V2500 Propulsion System — Nacelle

SERVICE BULLETIN

Subject: Transmittal of Revision 1 to Service Bulletin Number V2500-NAC-78-0087

**NACELLE — EXHAUST — VENT HOLES,
LEFT THRUST REVERSER DOOR — MODIFICATION AND ADDITION OF**

Thrust Reverser Fixed Duct Modification
Figure 1

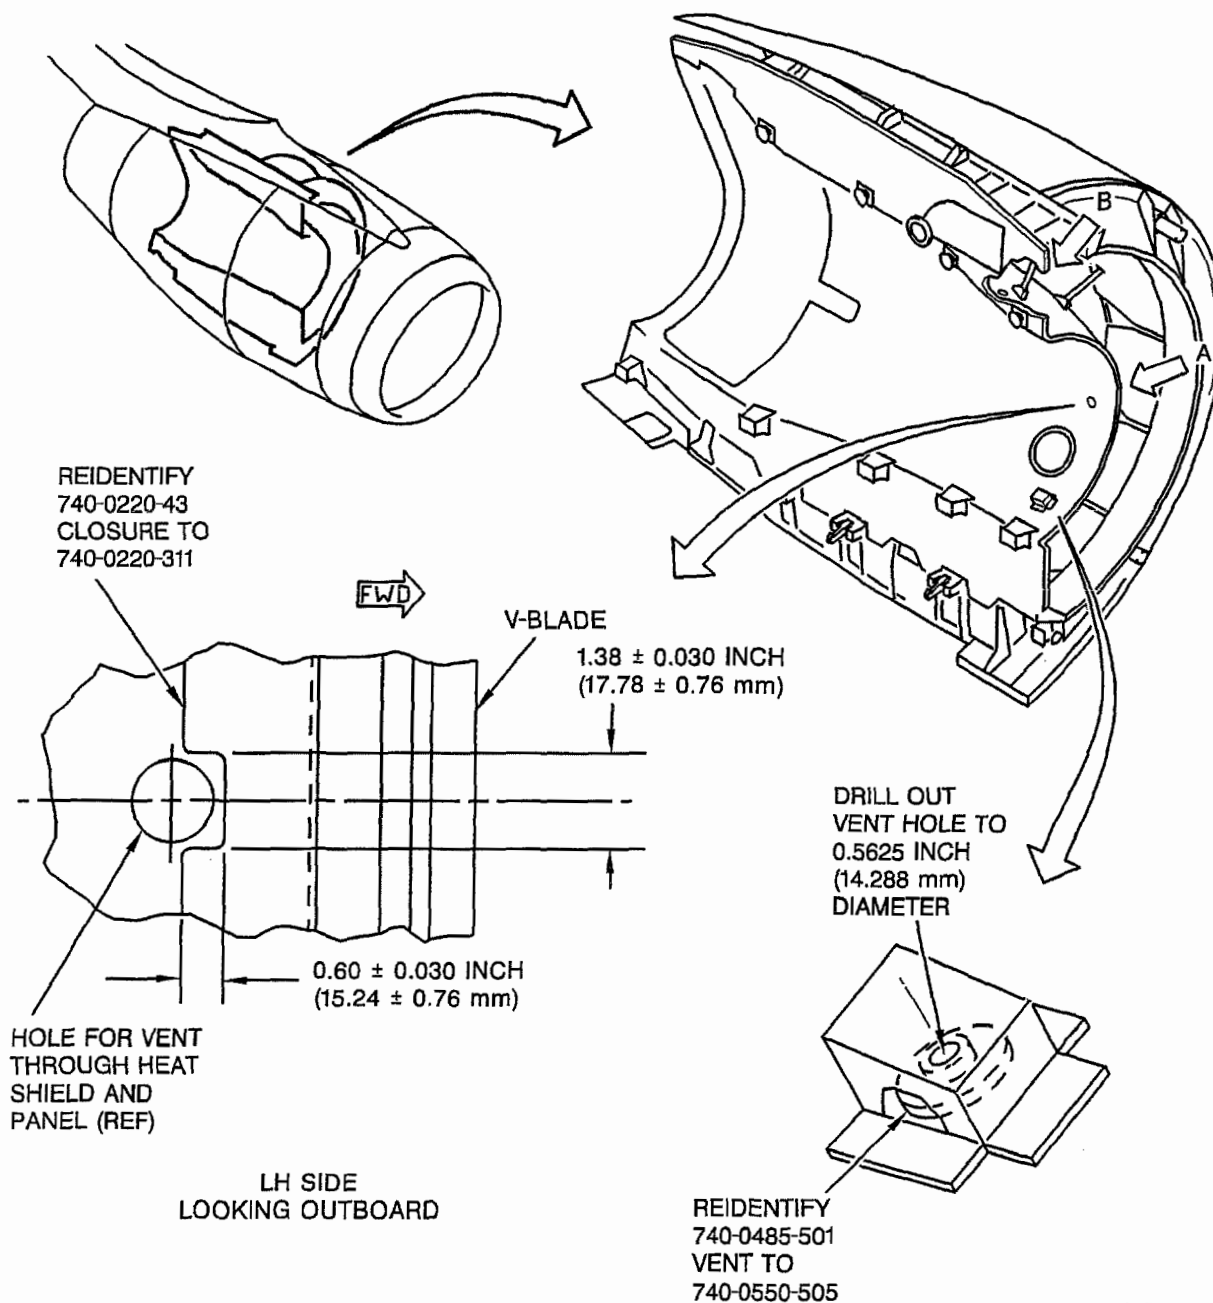
The change introduced by this Bulletin is to make a vent hole larger and install two new vents. This service bulletin should be done at the same time as IAE Service Bulletin V2500-NAC-78-0095.

- (1) Find the 740-0485-501 vent on the left thrust reverser half. Refer to Figure 1.
- (2) Use a drill to make the diameter of the hole in the vent 0.5625 inches (14.288 mm).

- (c) Remove material from the closure as shown in Figure 1. Put a piece of metal between the closure and the heat shield to prevent damage to the heat shield.

Thrust Reverser Fixed Duct Modification
Figure 3

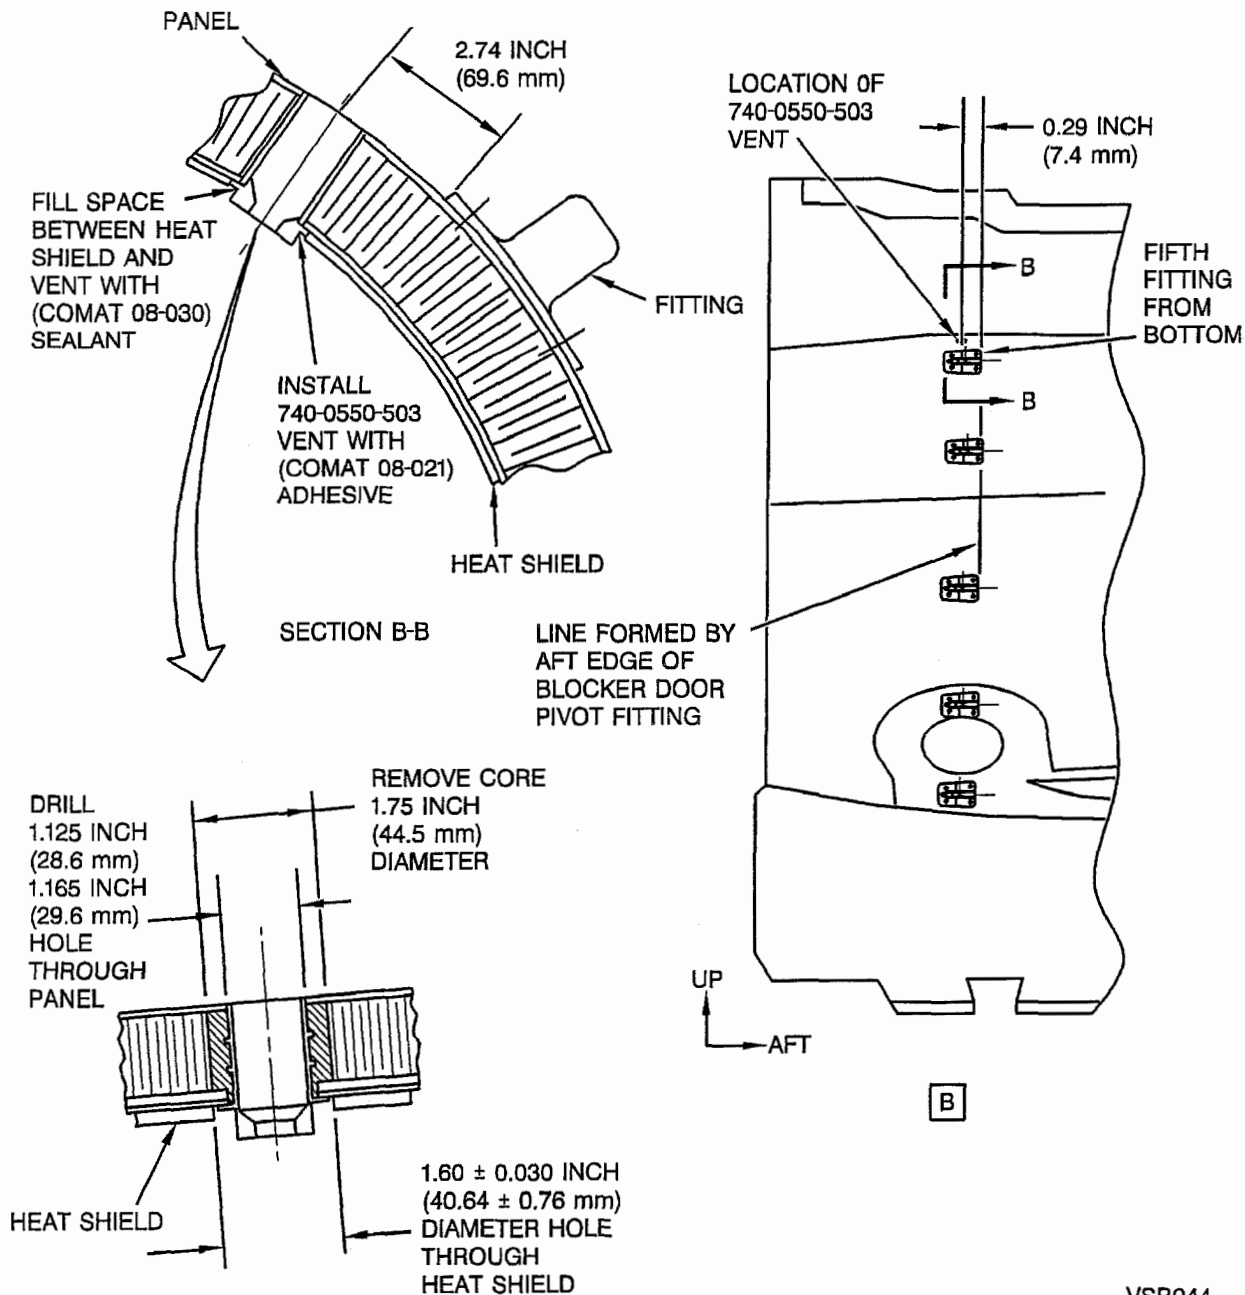
(1) To revise some text in Figure 3.
